North American Tungsten Corporation Limited

**RESPONSE TO YESAB'S ADEQUACY REVIEW REPORT
FOR THE PROPOSED MACTUNG MINE, MACMILLAN PASS, YUKON
(YESAB PROJECT NUMBER: 2008-0304)**

ADDENDUM 1 OF THE MACTUNG PROJECT PROPOSAL

July 2009

**Photo 2**

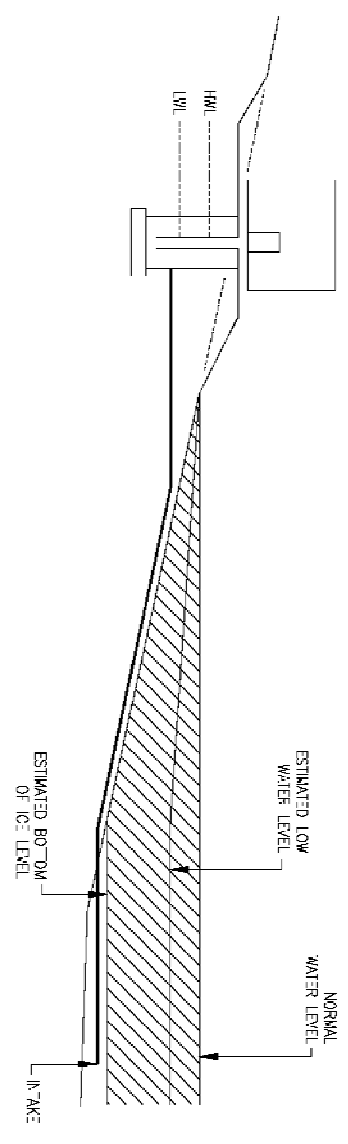
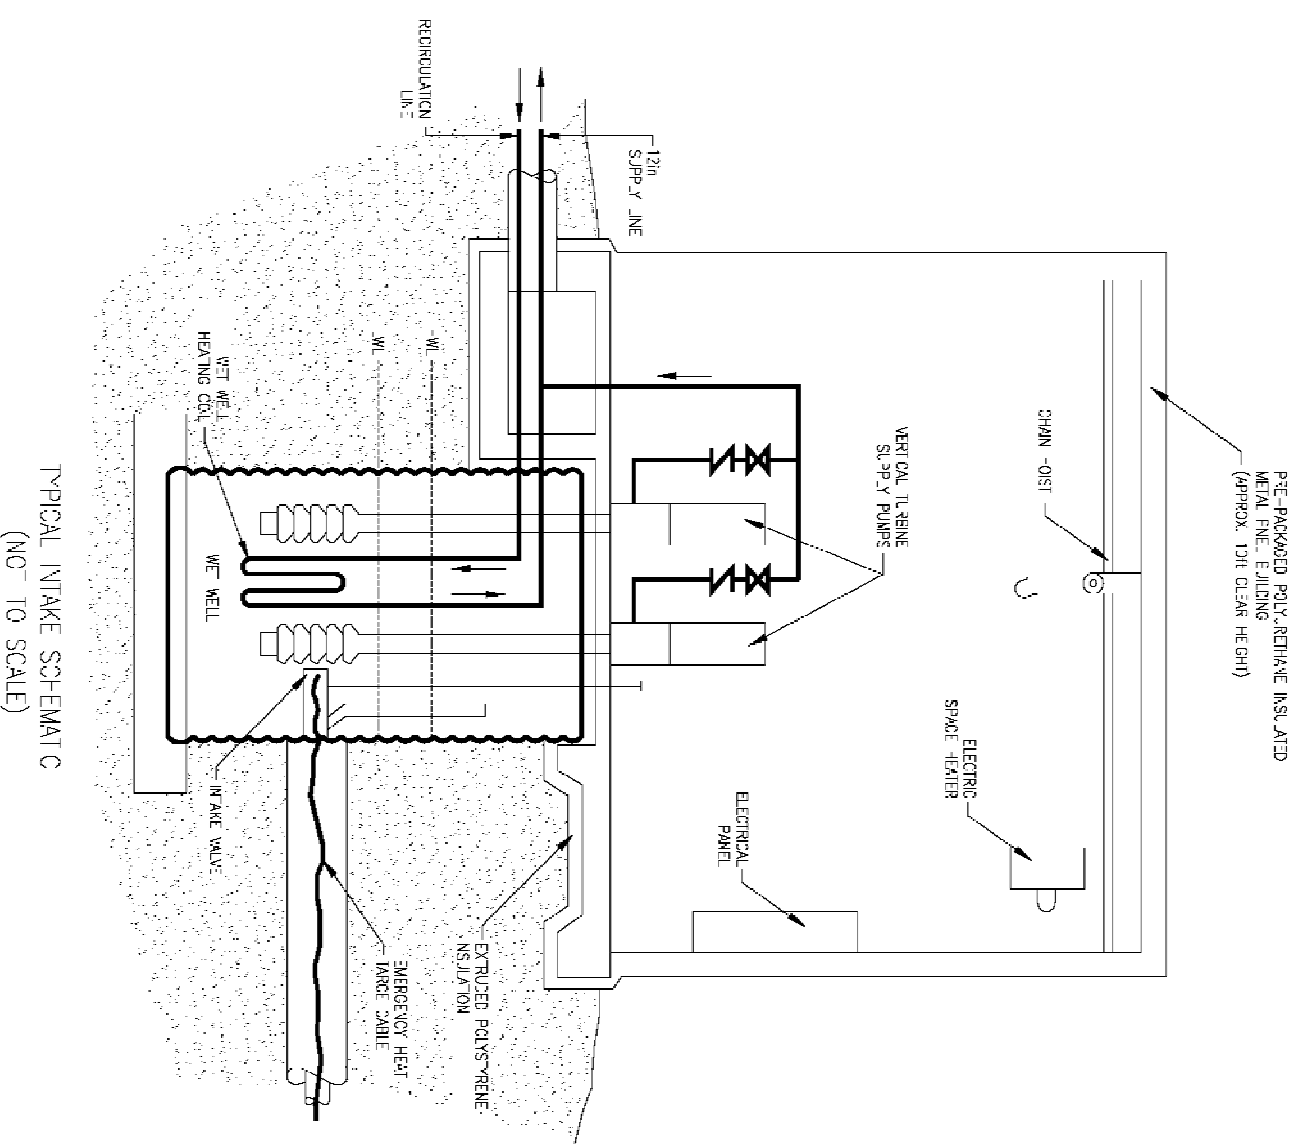
- b) Provide details of the stabilization efforts (e.g. purpose, associated activities) and design considerations (e.g. flooding, ice build-up) that will be taken with respect to the South Macmillan River, as referenced on pages 594 and 595 of the project proposal.

| <i>Not To Scale</i> | EBA Engineering Consultants Ltd. | | DATE JUNE 2009 | | Figure 3.2-1 |

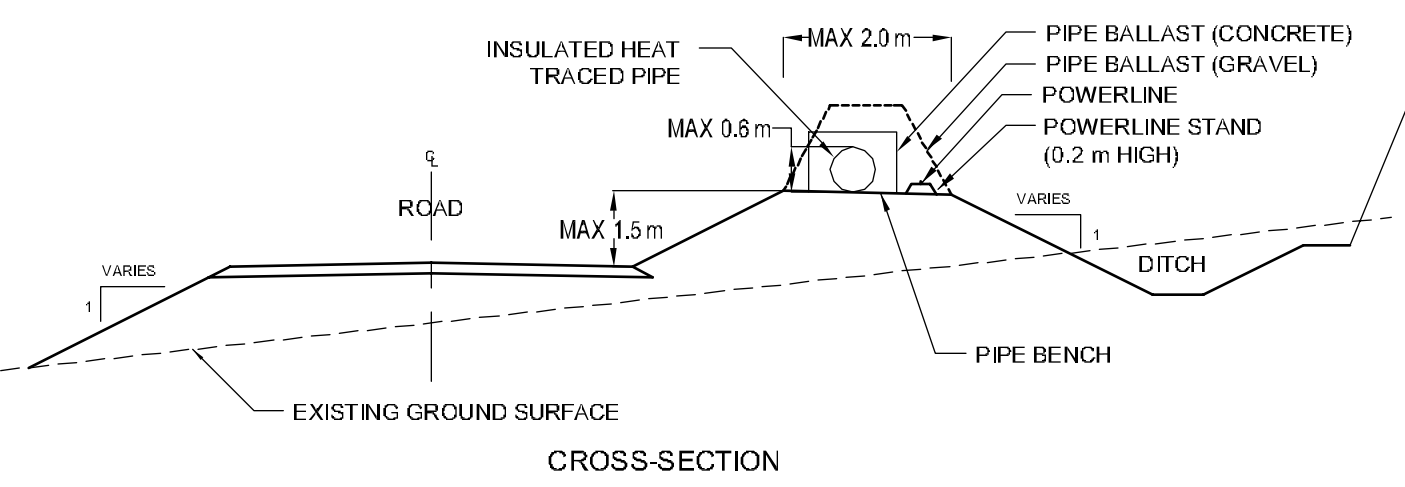
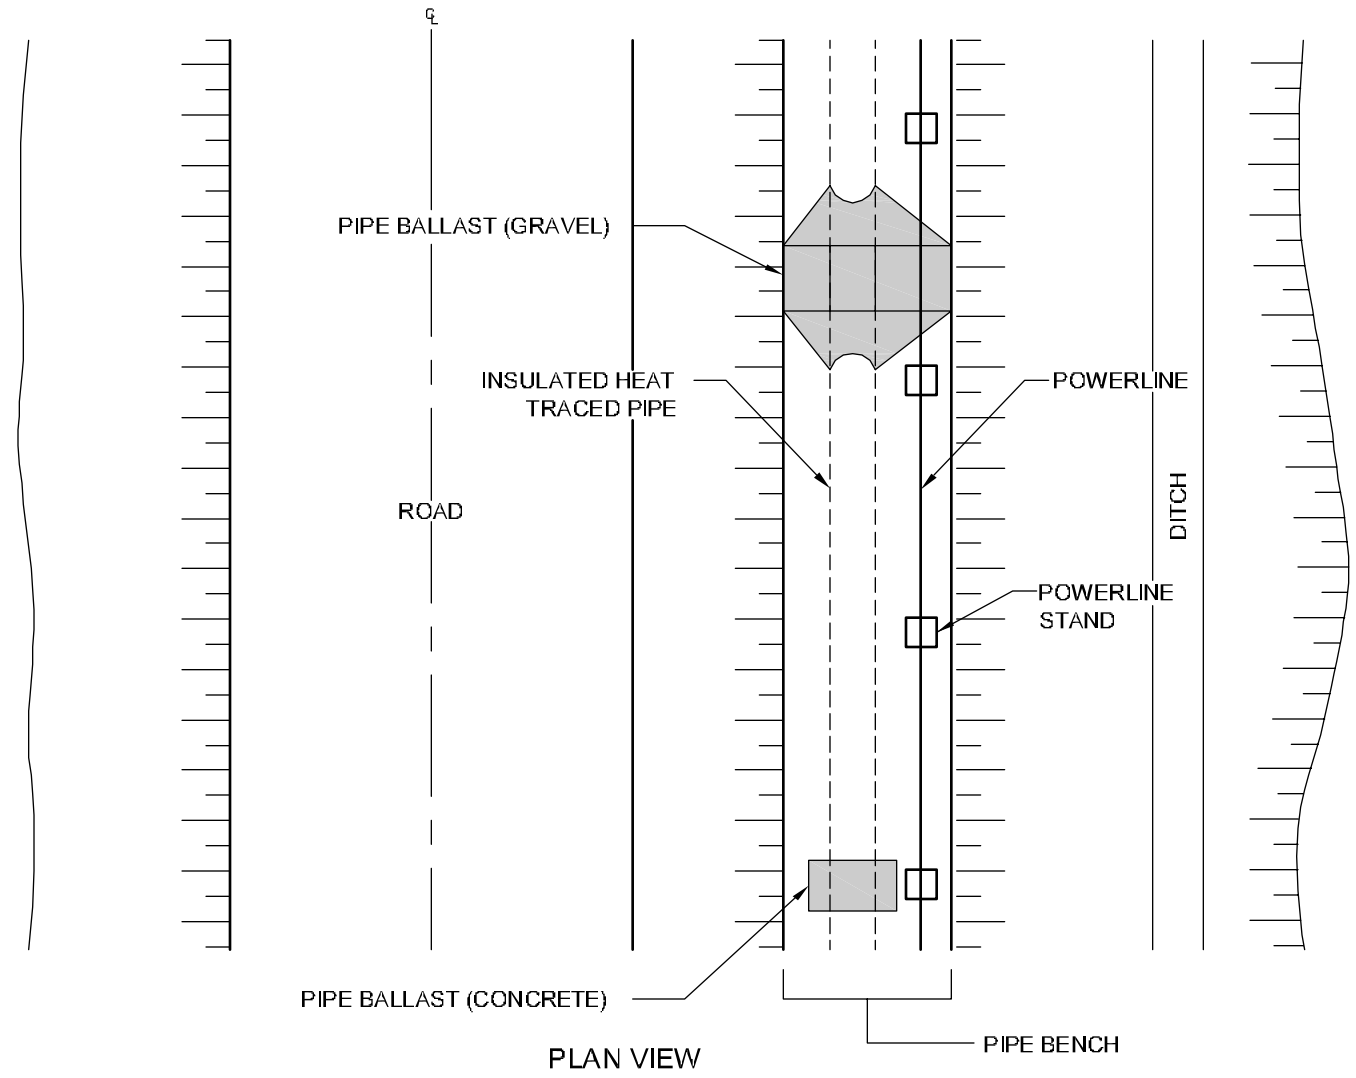
- a) Details on the design and construction of the pipeline bench (e.g. distance from road, height, width).

Updated plan and profile drawings of the pipe bench are included in Figure 3.2-1.

The details of the pipeline are shown in Figure 3.2-1. The pipeline rests directly on the pipe bench and ranges in diameter from 100 to 250 mm (could be up to 600 mm OD with insulation). Details on the size and number of pipe ballasts will be determined during detailed design; however, it is expected to be in the range of one ballast for every 10 to 30 m along the pipeline. The ballast will be designed based on the diameter and pressure of the pipeline, and will be constructed from either gravel fill or concrete covered in gravel fill. If gravel fill is used the ballast is expected to be approximately 1.5 m high from the pipe bench and 2 m long. The gravel will be contoured to allow wildlife to cross the pipe bench, even though the pipeline is not considered to be a barrier to wildlife. It is anticipated that one gravel ballast will be contoured for each kilometre of the pipeline.

The power line will rest on a small stands or wooden blocks, approximately 0.2 m high. The location of the power line is shown in Figure 3.2-1.

Figure 3.7-1

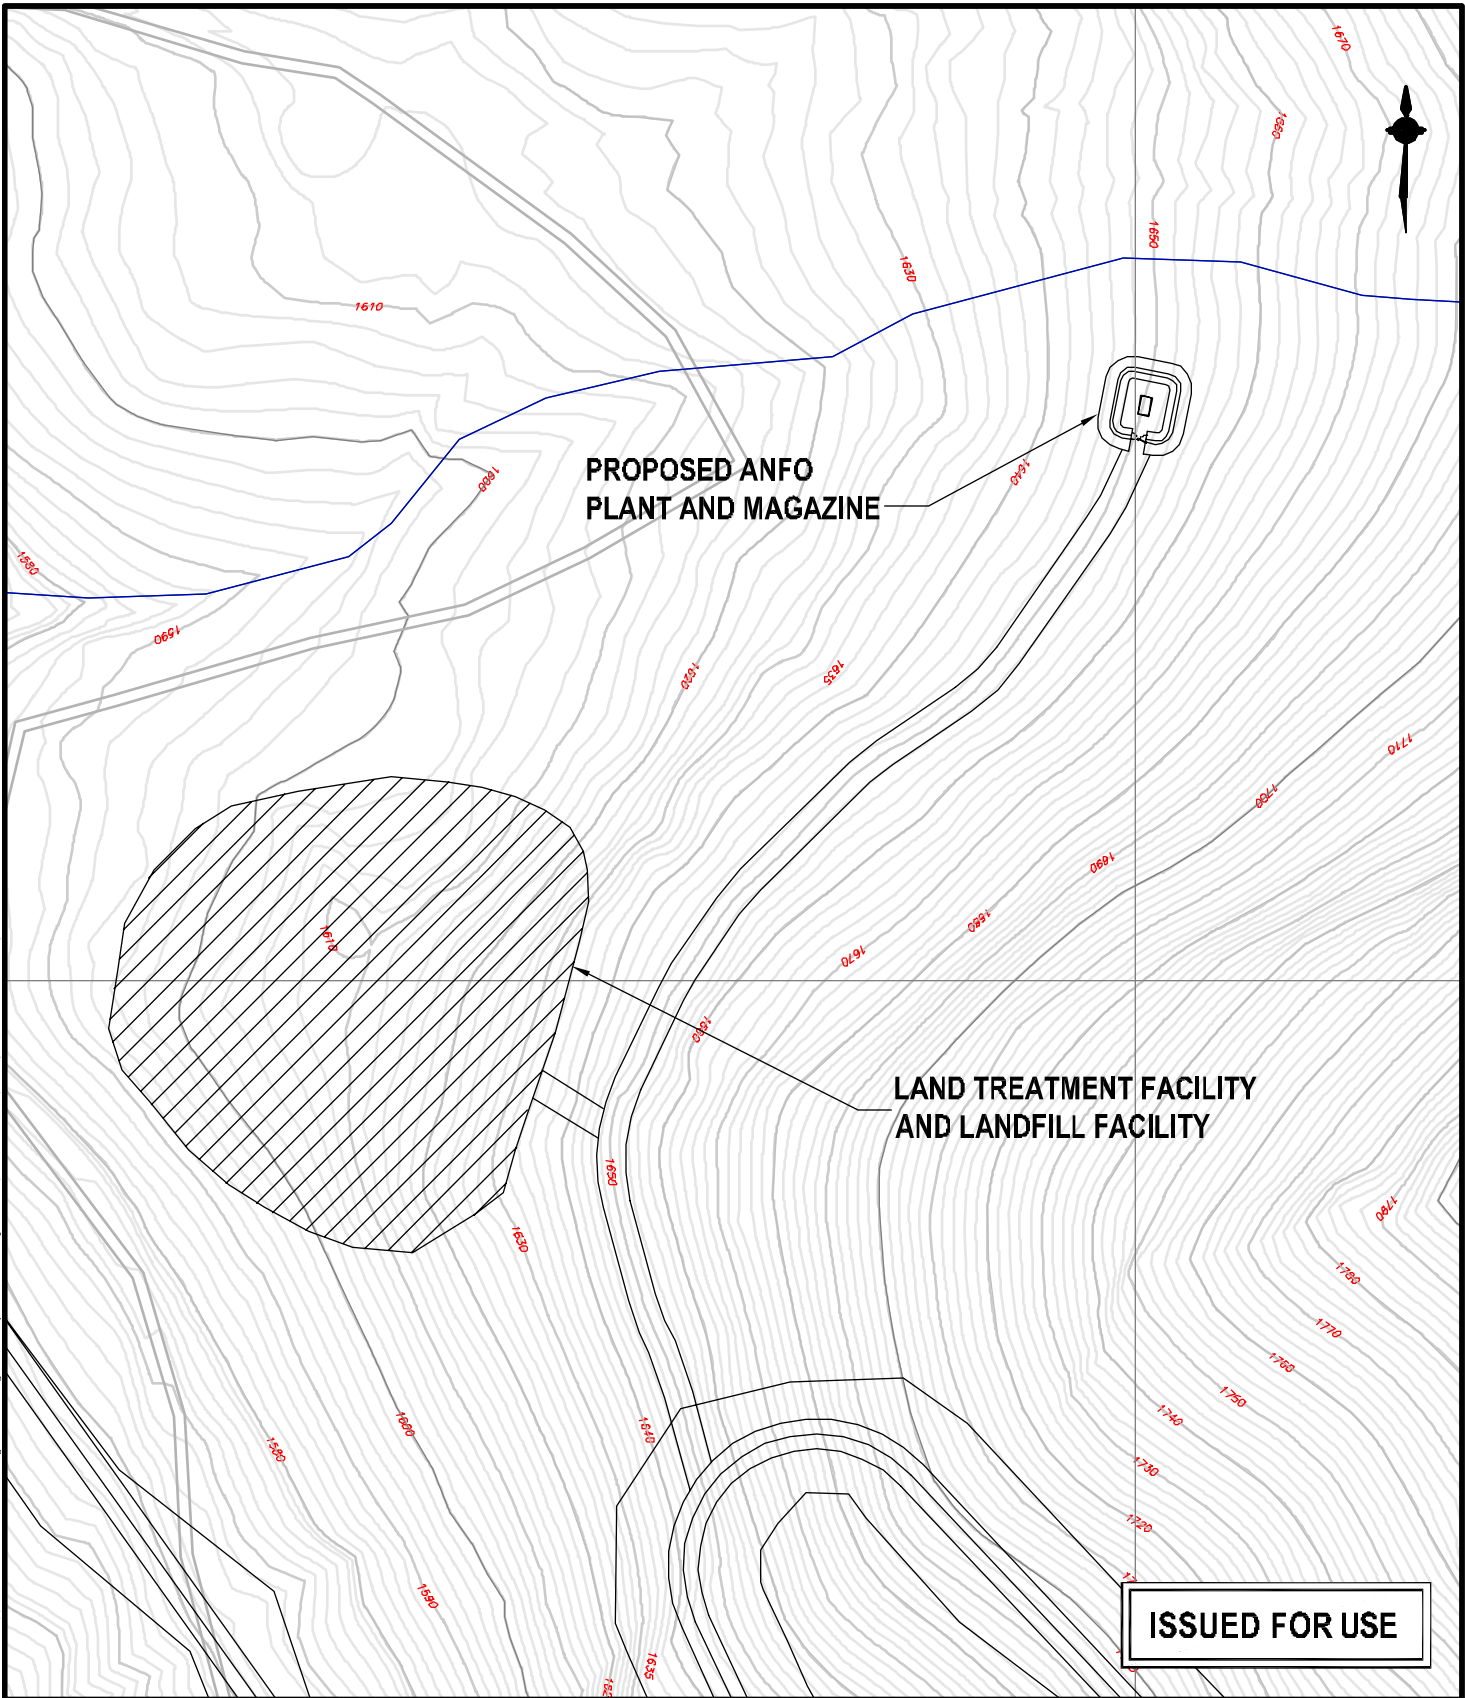
Ammonia Nitrate Fuel Oil (ANFO) explosives will be used during the construction phase of the project as well as for underground long-hole blasting during the operations phase. Explosives will be manufactured on-site at the ANFO emulsion plant that is to be located on the west side of Mount Allen (p.404). The proposal states that the location is shown on Figure 5.4.3-8. In fact the figure does not reveal the specific location of the plant, nor does it provide an adequate understanding of the terrain and topography immediately surrounding the ANFO plant and its access road. Therefore, please provide the following information.

The location of the ANFO plant is shown in Figure 3.7-1. A more detailed map showing the surrounding topography is provided in Figure 3.7-2.

The proposed general location of the LTF is provided in Figure 3.7-1 and will be adjacent to the landfill to help with the efficient excavation and use of material during construction and decommissioning. The LTF will be located within the polygon shown in the figure, in an area that will ensure that the above noted conditions are met. The depth to groundwater in the area will be confirmed by testpitting at the site prior to construction. If required, additional inert material will be placed to increase the liner elevation over the seasonal high groundwater table.
